ZONING AMENDMENT,
PLANNED UNIT DEVELOPMENT &
SUBDIVISION STAFF REPORT

Date: September 18, 2008

<u>NAME</u>	Hillcrest South, LLC
<u>SUBDIVISION NAME</u>	Uniport Subdivision, Resubdivision of and Addition to Lot 2
<u>LOCATION</u>	4616 and 4628 Airport Boulevard (North side of Airport Boulevard, 125'± East of South University Boulevard, extending to the East side of South University Boulevard 118'± North of Airport Boulevard).
<u>CITY COUNCIL DISTRICT</u>	District 5
<u>PRESENT ZONING</u>	R-1, Single-Family Residential, and B-2, Neighborhood Business
<u>PROPOSED ZONING</u>	B-2, Neighborhood Business
<u>AREA OF PROPERTY</u>	1 Lot/1.8± Acres
<u>CONTEMPLATED USE</u>	<p>Rezoning from R-1, Single-Family Residential, and B-2, Neighborhood Business District, to B-2, Neighborhood Business District, to eliminate split zoning and allow retail sales in a proposed commercial subdivision, Planned Unit Development Approval to allow shared access and parking between two building sites, and Subdivision to create a legal lot of record from three legal lots of record.</p> <p>It should be noted, however, that any use permitted in the proposed district would be allowed at this location if the zoning is

SITE PLAN

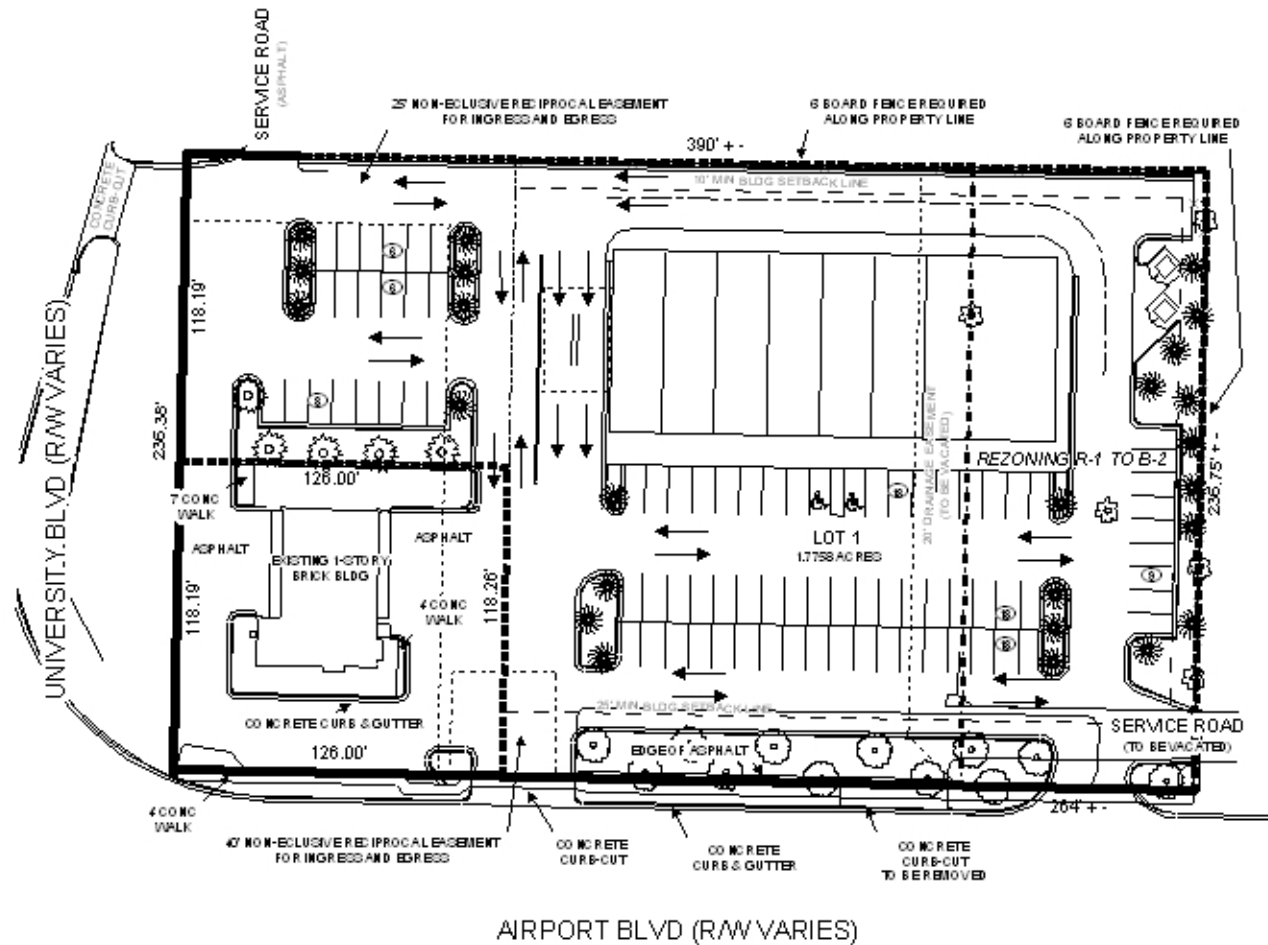
The applicant is proposing an 11,900 square-foot commercial building and 84 parking spaces. Access to the proposed development will be via two, two-way driveways from Airport Boulevard and one, two-way driveway from University Boulevard South. As stated in Traffic Engineering comments, both accesses from the service roads should be closed to avoid

circulation conflicts. The applicant also illustrates the vacation of an existing service road; therefore, the completion of the vacation should be required prior to the signing of the Final Plat.

The site abuts R-1, Single-Family Residential to the South and East; therefore, the site should be required to provide a minimum 6-foot high wooden fence. However, the applicant is proposing a 10-foot buffer to the East as well as the 6-foot high solid privacy fence. As this exceeds the minimum requirements, it should be stated as a condition of approval for both rezoning and PUD, as offered by the applicant. Therefore, the site plan should be revised to provide the 10-foot buffer at the southeast corner of the development.

It should be noted that there is an asphalt parking area within the right-of-way along University Boulevard South that should be removed and grassed.

- 1) placement of a note on the site plan stating that PUD approval is site plan specific, and that any changes to the site plan, will require a new application to the Planning Commission;
- 2) revision of the site plan to place the requirements of Section 64-6.A.3.c., *Lighting*, as a note on the site plan: “*If parking areas contain ten (10) or more cars, lighting shall be provided and maintained during their operation, and shall be so arranged that the source of light does not shine directly into adjacent residential properties or into traffic.*”
- 3) revision of the site plan to depict compliance with the tree and landscaping requirements of the Zoning Ordinance;
- 4) the closures of both service road accesses;
- 5) vacation of the service road as illustrated on the proposed site plan; and
- 6) full compliance with all other municipal codes and ordinances.

- 1) the dedication to provide sufficient right-of-way along Airport Boulevard and University Boulevard South 50-feet from the centerline of each street;
- 2) placement of a note on the final plat stating that the development is limited to two, curb-cuts onto Airport Boulevard and one, curb cut to University Boulevard South, with the size, design and location to be approved by Traffic Engineering, and in conformance with AASHTO standards;
- 3) completion of the vacation process prior to the signing of the Final Plat;
- 4) placement of a note on the Final Plat denying access from both service road; and
- 5) revision of the Final Plat to label the lot with its size in square feet.
